# ***Preliminary Value Analysis Study Report***

## ***D-3 US 50 Camino Safety Project***

**PN 0314000039**

**03-ED-50-PM 21.95-24.25**

## VALUE ANALYSIS ALTERNATIVE 1.0

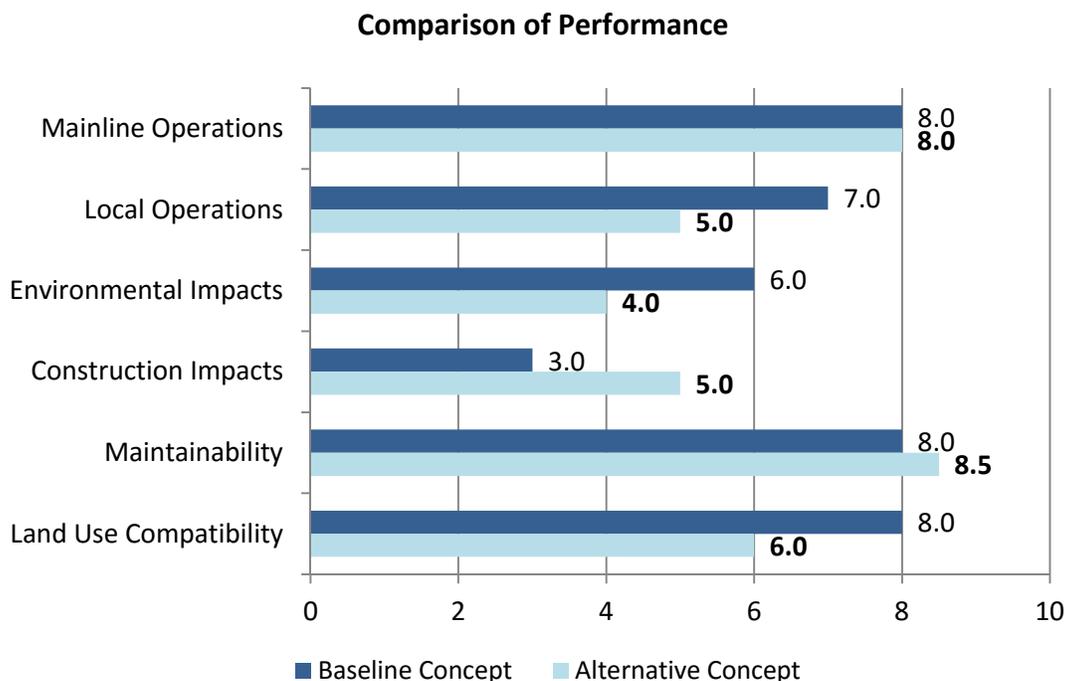
**Description of Alternative Concept:** The VA alternative proposes to eliminate those features that are being constructed to maintain local and regional access to and from the north and south sides of US 50 while providing safe east-west access on and off US 50, the secondary purpose of the project. Further, no improvements that are off the US 50 mainline will be made.

**Discussion:** This alternative will present the lowest cost that will achieve the primary purpose and need of the project. This concept proposes full median barrier closure from the existing barrier west of Still Meadows to the existing barrier east of Upper Carson Road. There would be construction cost and time savings. Performance would be decreased in some areas. The proposed median barrier would be designed with probably two or three opening locations (and signs) that would accommodate emergency vehicles. This alternative would be considered if local improvements cannot be advanced and potentially extend the project completion date.

**Technical Review Comments:** Shoulders will be widened and improve the geometry. There is a concern that motorists may use the openings. Comment: Delineators will be installed or barriers will be offset with a gap to accommodate emergency vehicle movements.

## VALUE ANALYSIS ALTERNATIVE 2.1

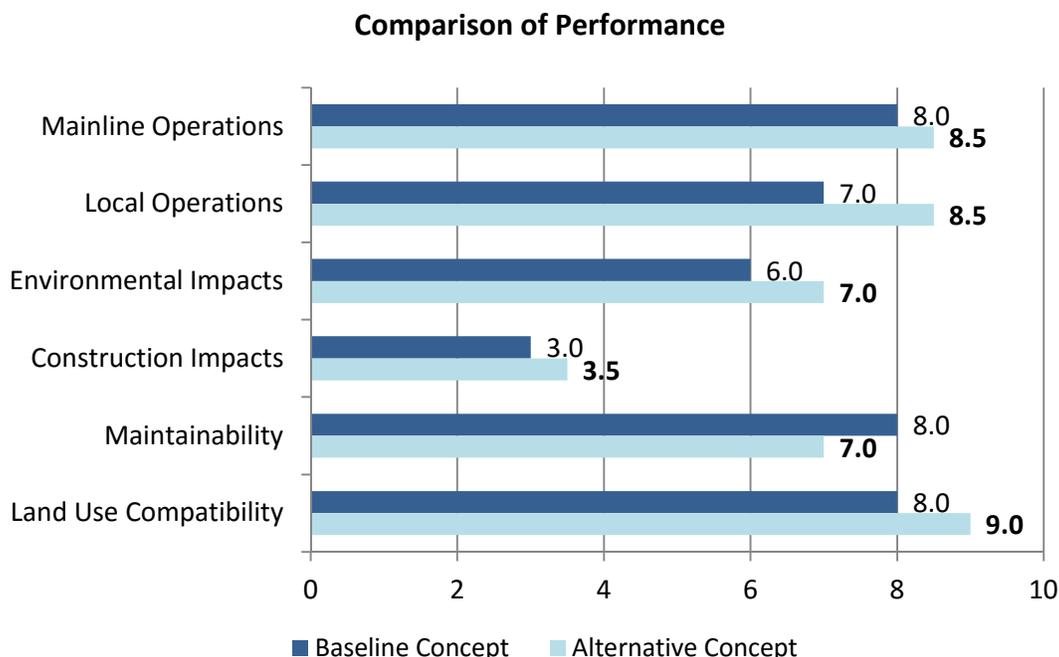
**Description of Alternative Concept:** This alternative proposes to widen US 50 for the installation of concrete median barrier from west of Still Meadows Road to the existing concrete median barrier located east of Upper Carson Road. A new frontage road would connect Paul Bunyan to Camino Heights at Sierra Blanca. A new eastbound off-ramp would be constructed that would close Camino Heights Drive at US 50 and Sierra Blanca Road at US 50. The eastbound off-ramp would connect to a new roundabout intersection south of US 50. A new eastbound on-ramp would connect the roundabout to US 50. The roundabout would connect under US 50 to a roundabout on the north side of US 50 to Carson Road. A new local road connection would be built from the south roundabout to Camino Heights Drive via Golden Chain Drive and Vista Tierra Drive. Class II bike lanes and sidewalk will be included as part of the undercrossing.

**Discussion:** Based on preliminary public outreach, local residents have voiced concerns about the traffic impacts on local neighborhoods from the baseline concept. This alternative was developed to address local concerns while maintaining north and south access across US 50. The roundabout will provide smoother traffic flows and reduce greenhouse gas. Safety will be improved by reducing the severity of intersection related collisions. Allows segregated traffic flow for residents of the Camino Heights area by way of frontage connection to Paul Bunyan Road. Right-of-way acquisition may be easier because of less impact to existing land use. The existing Camino Park and Ride would have minor impacts because of the elimination of a few parking stalls vs. the entire elimination of the Park and Ride facility as proposed in the baseline concept. NOTE: The baseline concept is proposed to be a mitigated negative declaration. This VA alternative may lessen the risk of a higher level and costlier environmental document because of a more favorable and acceptable design.

**Technical Review Comments:** Interchange spacing to Cedar Grove is over 2 miles and would meet standards. There is a concern about enough length to effectively operate acceleration and deceleration lanes. Ensure that the ramp and diverge areas are built to standard. Ensure that ADA compliance and “complete streets” standards are evaluated and met.

## VALUE ANALYSIS ALTERNATIVE 2.2

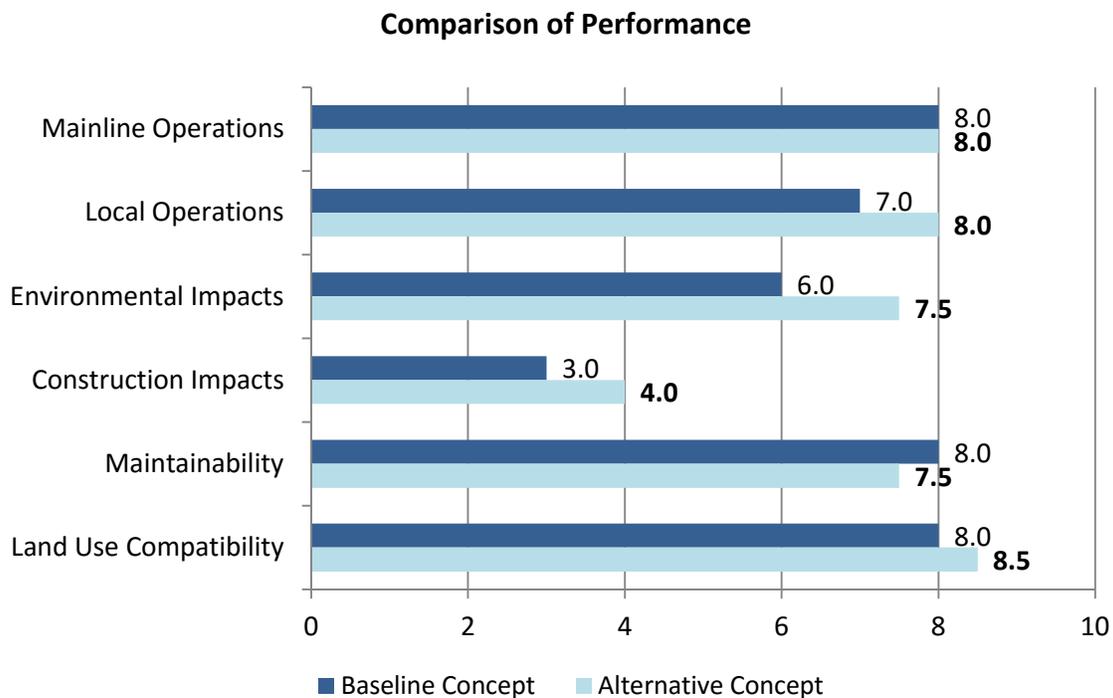
**Description of Alternative Concept:** The alternative proposes to widen US 50 for the installation of concrete median barrier from west of Still Meadows Road to the existing concrete median barrier located east of Upper Carson Road. A new eastbound off-ramp would be constructed that would close Camino Heights Drive at US 50 and Sierra Blanca Road at US 50. The eastbound off-ramp would connect to a new roundabout intersection south of US 50. A new eastbound on-ramp would connect the roundabout to US 50. The roundabout would connect under US 50 to a roundabout on the north side of US 50 to Carson Road. A new local road connection would be built from the south roundabout to Camino Heights Drive via Golden Chain Drive and Vista Tierra Drive. Class II bike lanes and sidewalk will be included as part the undercrossing.

**Discussion:** Based on preliminary public outreach, local residents have voiced concerns about the traffic impacts on local neighborhoods from the baseline concept. This alternative was developed to address local concerns while maintaining north and south access across US 50. The roundabout will provide smoother traffic flows and reduce greenhouse gas. Safety will be improved by reducing the severity of intersection related collisions. Right-of-way acquisition may be easier because of less impact to existing land use. The existing Camino Park and Ride would have minor impacts because of the elimination of a few parking stalls vs. the elimination of the entire Park and Ride facility as

**Technical Review Comments:** Interchange spacing to Cedar Grove is over 2 miles and would meet standards. There is concern about having enough length to effectively operate acceleration and deceleration lanes. Ensure that the ramp and diverge areas are built to standard. Ensure that ADA compliance and “complete streets” standards are evaluated and met.

## VALUE ANALYSIS ALTERNATIVE 2.3

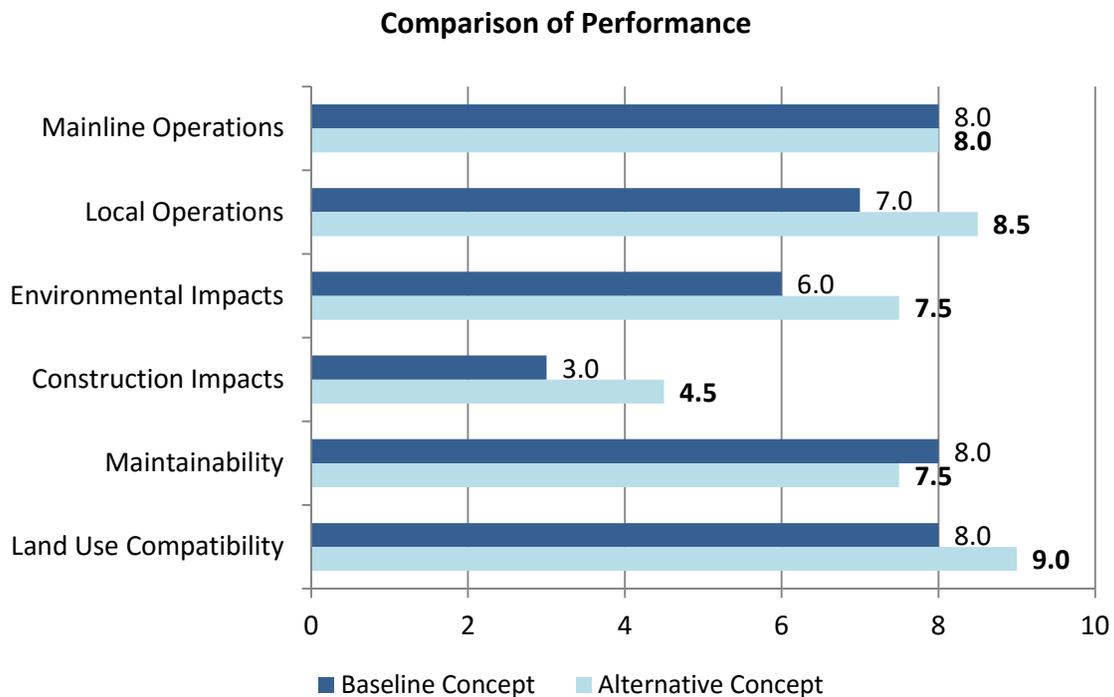
**Description of Alternative Concept:** The alternative concept proposes to widen US 50 for the installation of concrete median barrier from west of Still Meadows Road to the existing concrete median barrier located east of Upper Carson Road. A new two-lane eastbound off-ramp to Camino Heights would be constructed that would provide a right turn Camino Heights Drive at US 50. Also, two roundabouts at the undercrossing at US 50 would be constructed. A new eastbound on-ramp would connect the roundabout to US 50. The roundabout would connect under US 50 to a roundabout on the north side of US 50 to Carson Road. A new local road connection would be built from the south roundabout to Camino Heights Drive via Golden Chain Drive and Vista Tierra Drive. Class II bike lanes and sidewalk will be included as part the undercrossing.

**Discussion:** Based on preliminary public outreach, local residents have voiced concerns about the traffic impacts on local neighborhoods from the baseline concept. This alternative was developed to address local concerns while maintaining north and south access across US 50. The roundabout will provide smoother traffic flows and reduce greenhouse gas. Improvement in safety would be achieved by reducing the severity of intersection related collisions. Right-of-way acquisition may be easier

**Technical Review Comments:** Interchange spacing to Cedar Grove is over 2 miles and would meet standards. There is a concern about enough length to effectively operate acceleration and deceleration lanes. Make sure the ramp and diverge areas are built to standard. Ensure that ADA compliance and “complete streets” standards are evaluated and met. The right turn at Camino Heights needs adequate deceleration space.

#### Construct an undercrossing at Upper Carson with a roundabout connection to Carson Road with a roundabout on the north side of US 50

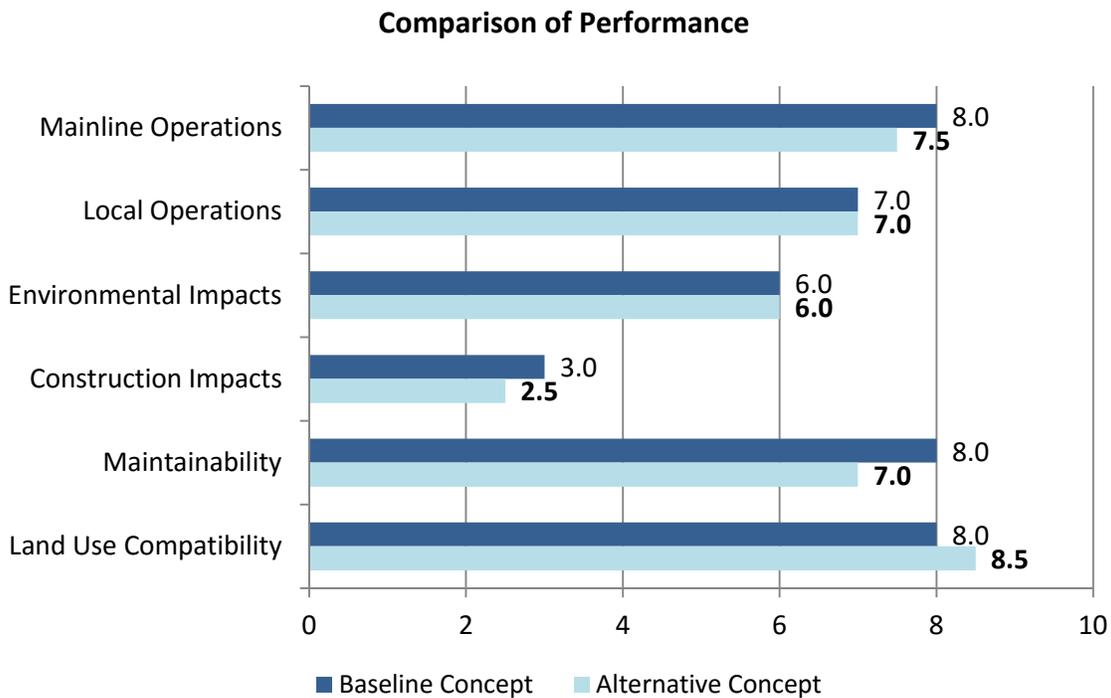
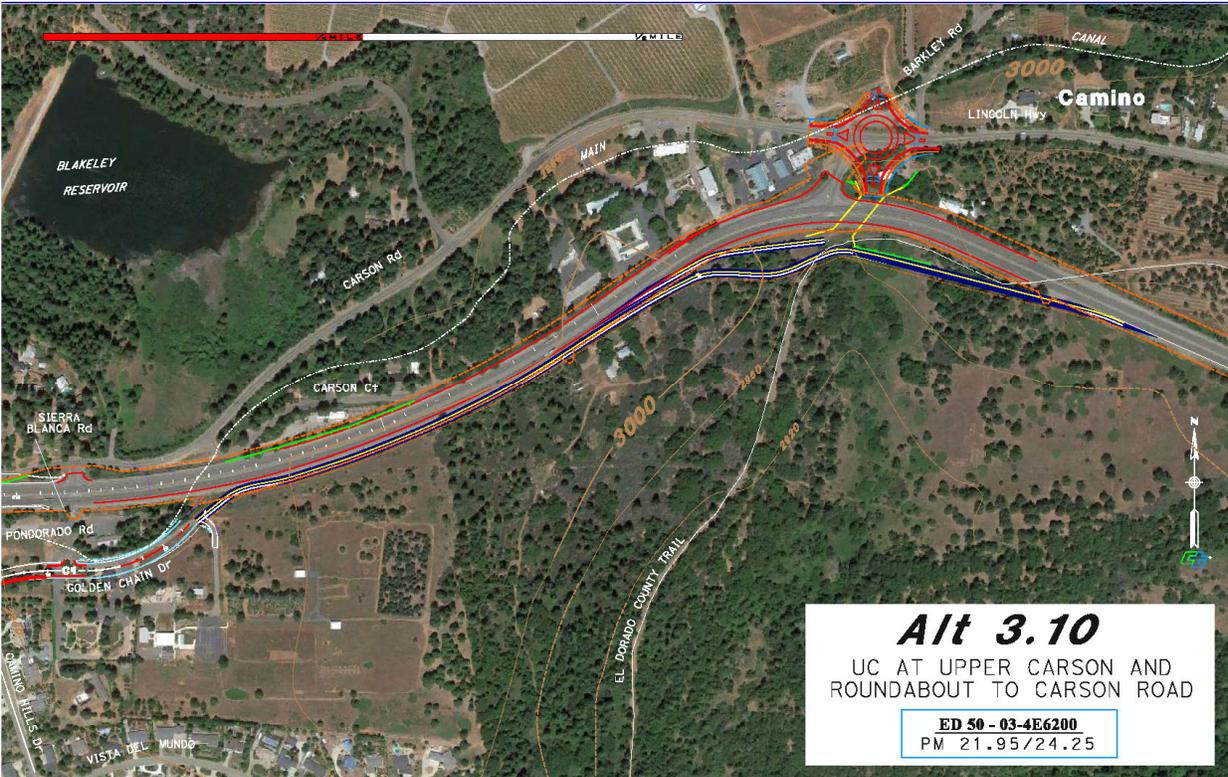
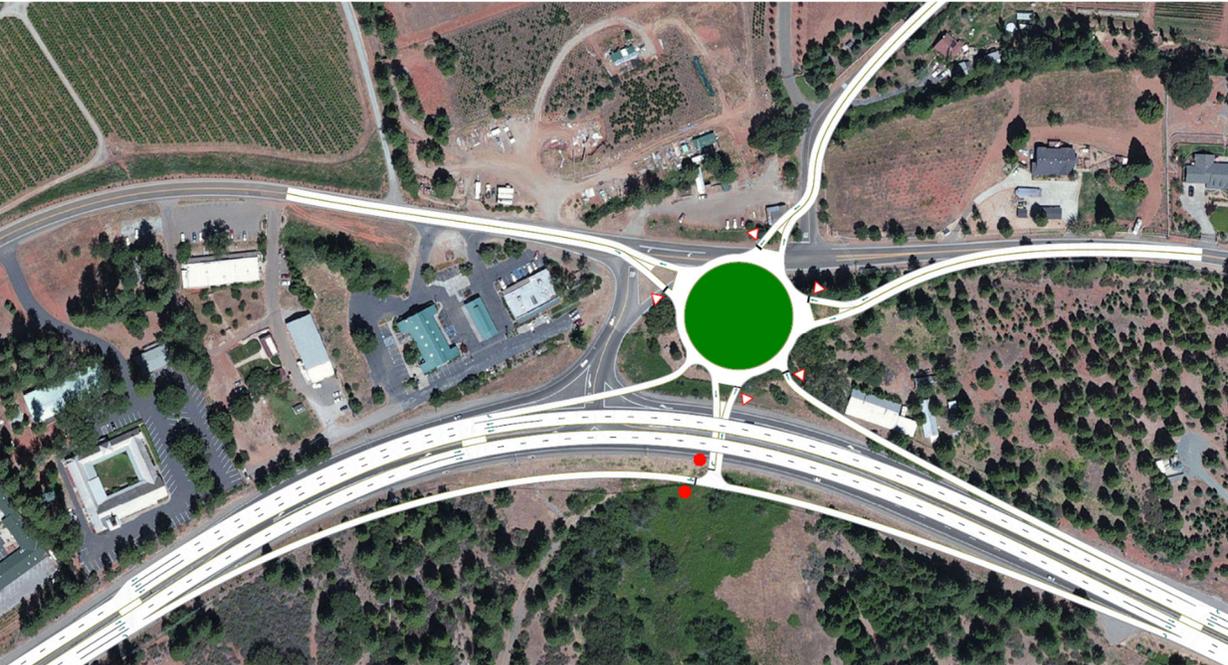
**Discussion:** Based on preliminary public outreach, local residents have voiced concerns about the traffic impacts on local neighborhoods from the baseline concept. The main benefit of this concept is to reduce impacts to the Camino Heights residents. It will also improve access to Upper Carson Road businesses. Therefore, this alternative is proposed to address local concerns while maintaining north and south access across US 50. The roundabout will provide smoother traffic flows and reduce greenhouse gas. Improvement in safety would be achieved by reducing the severity of intersection

related collisions. Right-of-way acquisition may be more difficult and costly. This alternative may require a higher level and costlier environmental document. Most likely the roundabout would be depressed into the existing topography. Drainage would be similar to the baseline concept.

**Technical Review Comments:** Close proximity to the existing Carson Road and Upper Carson Road intersection would require integration of the roundabout into the intersection. There is some geometric concern about matching grades and an oval shaped roundabout

## VALUE ANALYSIS ALTERNATIVE 3.2

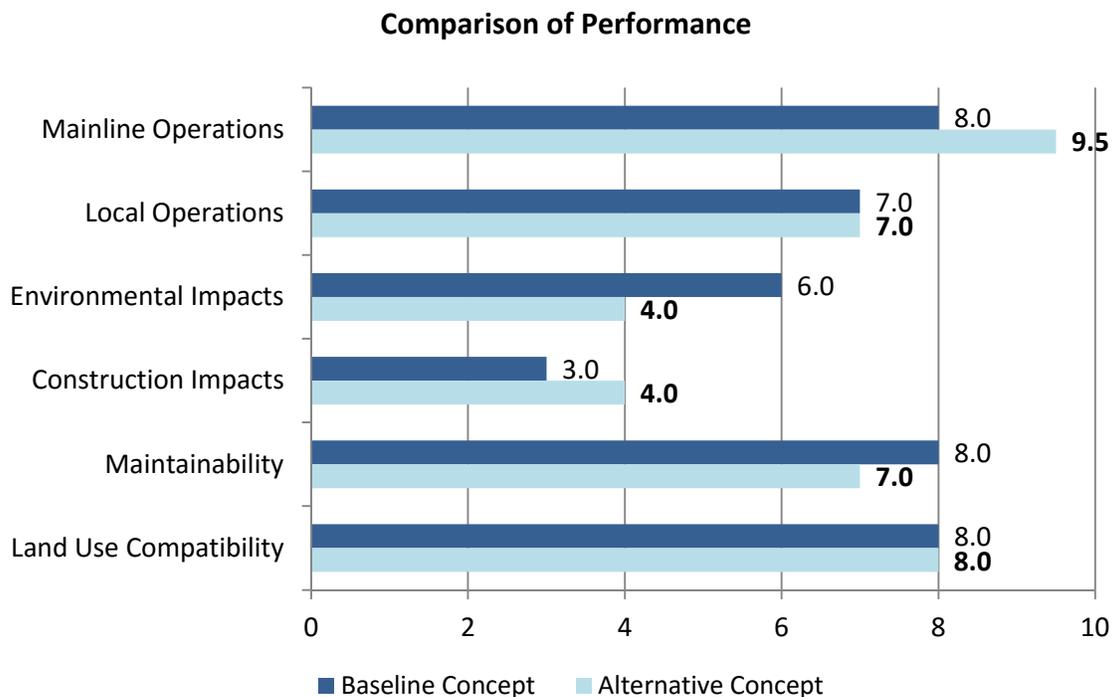
**Description of Alternative Concept:** This VA alternative proposes to construct the mainline improvements of the baseline concept, excluding local improvements which will be replaced by constructing a classic L-1 type interchange ¼ mile east of Upper Carson Road with frontage connection to Camino Heights. Consider constructing a park and ride/rest area facility between US 50 and Carson Road on the interchange access. Remove the Upper Carson Road access point to US 50.

**Discussion:** The main benefit of this alternative is that collisions would be reduced by closing Upper Carson Road access. A traditional interchange is safer than an at-grade interchange. There would be additional cost for the construction of an interchange and a frontage. The park and ride facility would enhance opportunities for transit mobility throughout the region. This concept is presented to explore alternatives in the vicinity of Upper Carson Road to reduce impacts on local neighborhoods and businesses.

**Technical Review Comments:** May need a design exception for interchange spacing. The distance is approximately 1.6 miles.
